**FEDERAL FACILITY AGREEMENT AND CONSENT ORDER (FFACO)  
RECORD OF TECHNICAL CHANGE (ROTC)**

**Corrective Action Unit (CAU) Number:** 426

**CAU Description:** Cactus Spring Waste Trenches (TTR)

**ROTC No.** DOE/NV/11718-226-ROTC 1 **Page** 1 **of** 9  
**Document Type** Closure Report (CR) **Date** 11/19/2019

**CAU 426, CAS RG-08-001-RGCS  
Waste Trenches  
FFACO UR Boundary**

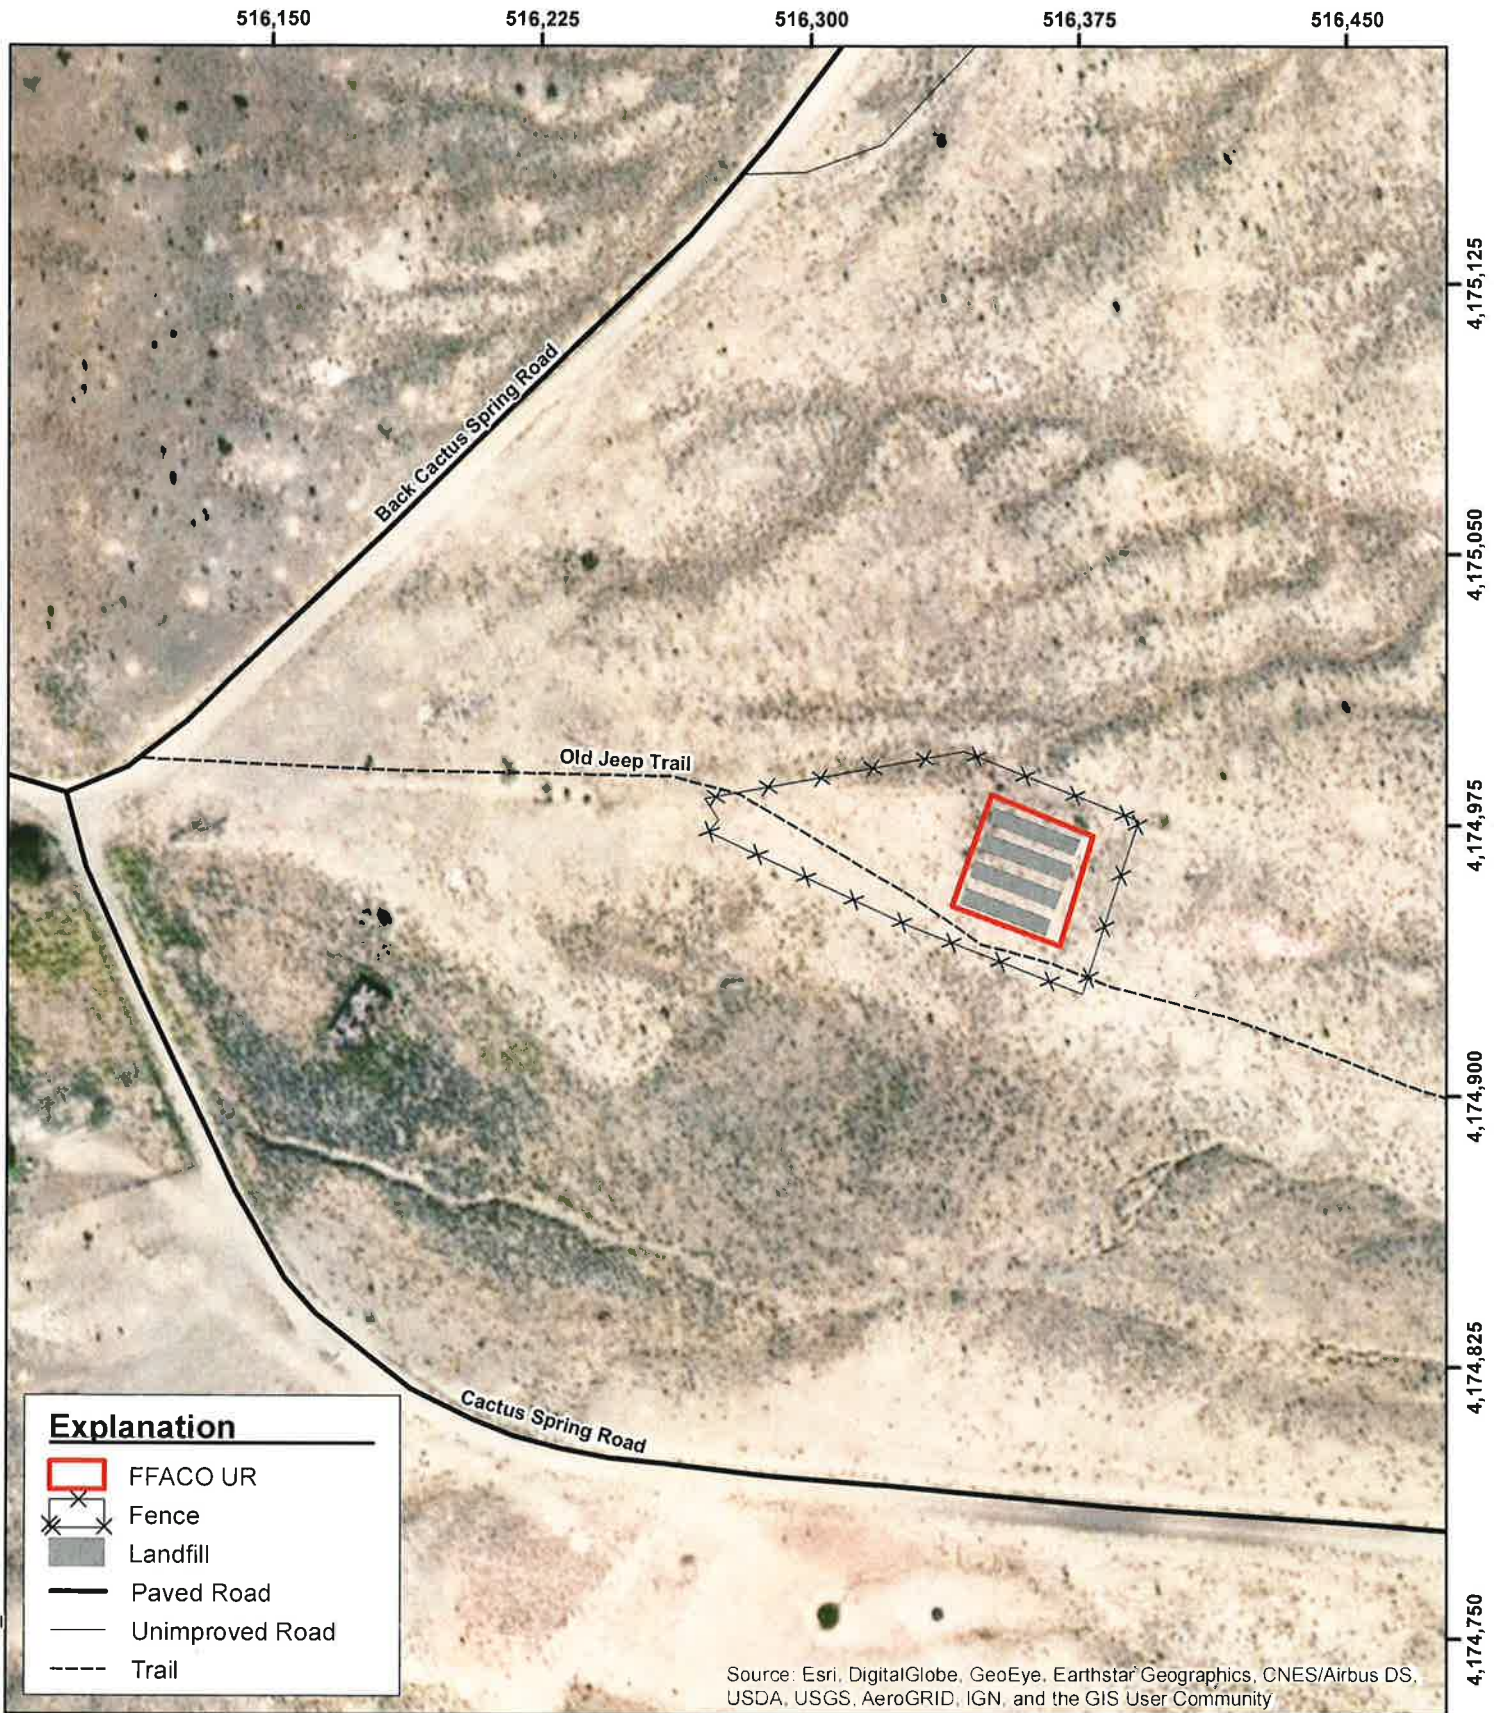
1. This ROTC replaces the Use Restriction (UR) information listed in the documentation for CAU 426.

UR forms have been updated to list all UR requirements, including but not limited to: post-closure site controls (signs, fencing, etc.), inspection and maintenance requirements, and Geographic Information Systems (GIS) coordinate information. The UR requirements and form(s) included in this ROTC represent the current corrective action requirements for each Corrective Action Site (CAS) in this CAU and supersede information concerning corrective action and post-closure requirements in existing documentation.
2. UR boundary coordinate values changed due to conversion from North American Datum (NAD) 83 State Plane Central (m) to NAD 1983 for CAS RG-08-001-RGCS.

1. Some changes in the UR requirements from those found in closure documents have been subsequently modified in letters, memos, and inspection reports. This has resulted in difficulty in determining current post-closure requirements. A review of the post-closure requirements for this CAU has been conducted to ensure that all requirements have been identified and documented on the new UR form. The new UR form was developed to be inclusive of all requirements for long-term monitoring and standardize information contained in the URs consistent with current protocols.
2. UR boundary coordinates need to be in one standardized coordinate system.
